May 4, 2021

Product Change Notice - Seal removed from piano hinge on 86 and 07 baggage doors

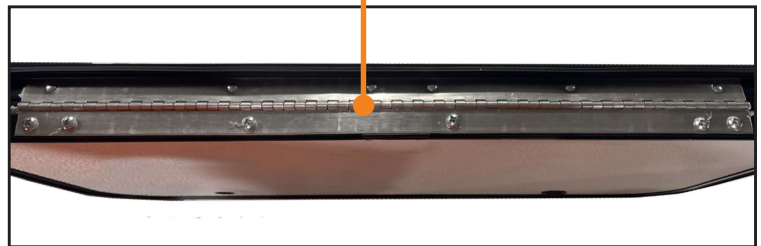
Please be advised, Lippert intends to remove the seal from the piano hinge on 85 and 07 series bag doors.

The change is being made to improve functionality. The seal puts pressure on the hinge when the door is closed. It was determined the hinge area has the same water intrusion mitigation with or without the seal. While the seal covers the screws, it does not affect how the screws are sealed against the frame.

There is no change in installation or operation with the seal removal. There is no price change. The change will take effect around the end of May.
